International  
Aero Engines

V2500 Propulsion System — Nacelle

NACELLE - FIRE PROTECTION - FIRE DETECTOR ASSEMBLIES AND SUPPORT  
BRACKETS, ACCESSORY AND CORE - REPLACEMENT OF

V2500-NAC-26-0008

ACCESSORY ZONE FIRE DETECTOR ASSEMBLY  
FIGURE 9

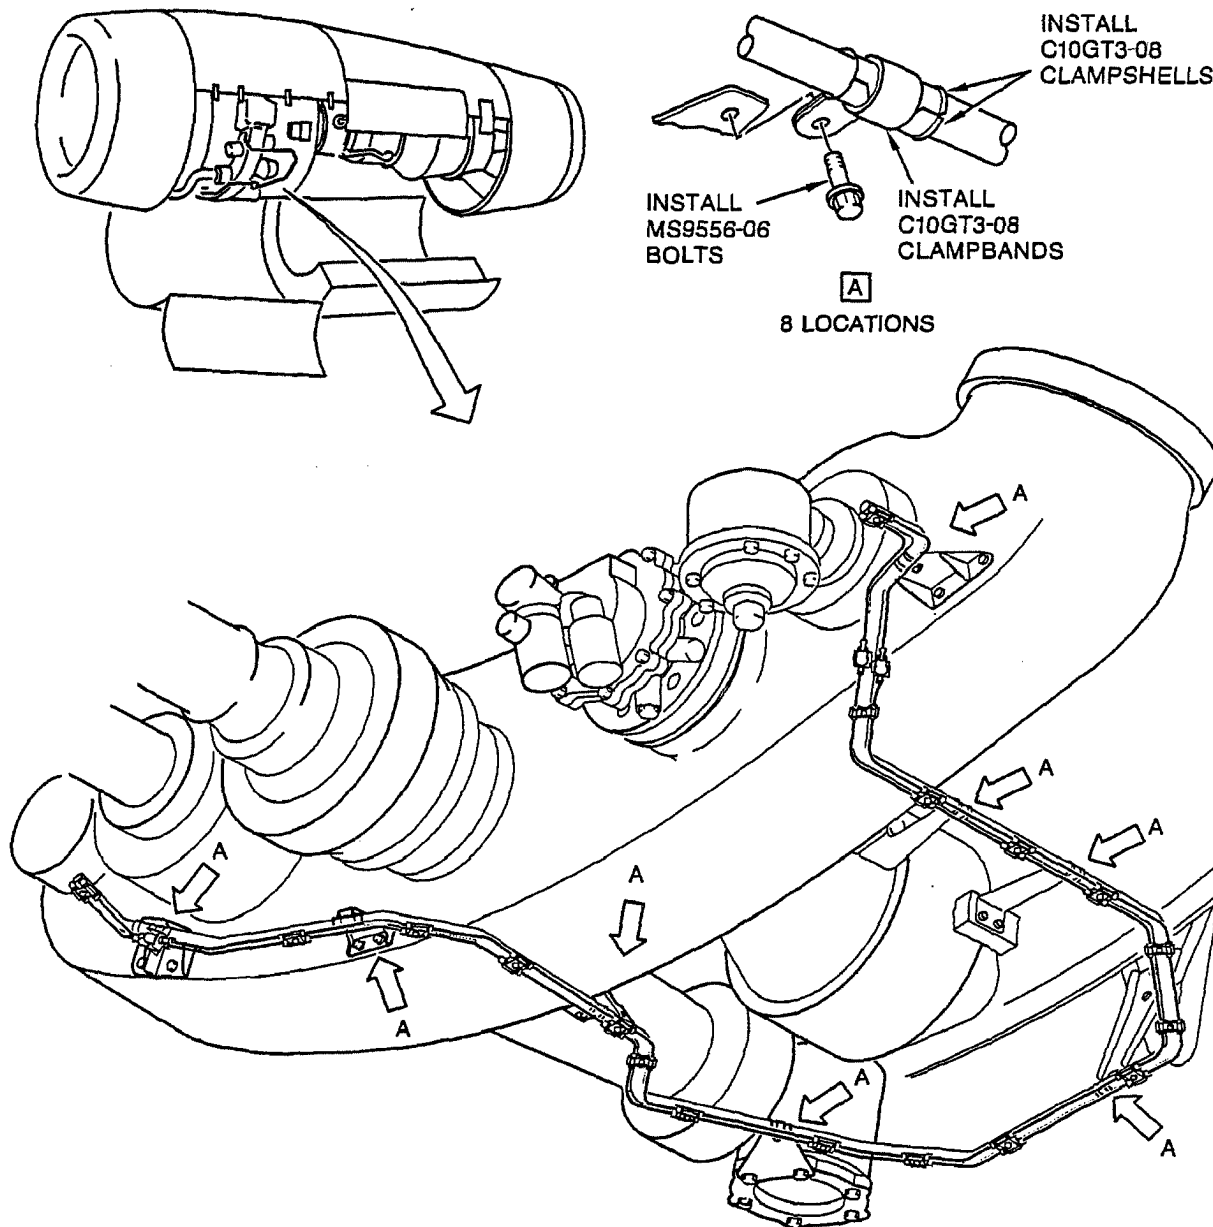
- (a) Put the 290-5132-519 fire detector assembly on the engine brackets with the eight sets of retained C10GT3-08 clampshells, eight C10GT3-08 clampbands, and eight MS9556-06 bolts. See Figure 9.
- (b) Torque the MS9556-06 bolts to 23-25 in-lb (2.6-2.8 Nm.).
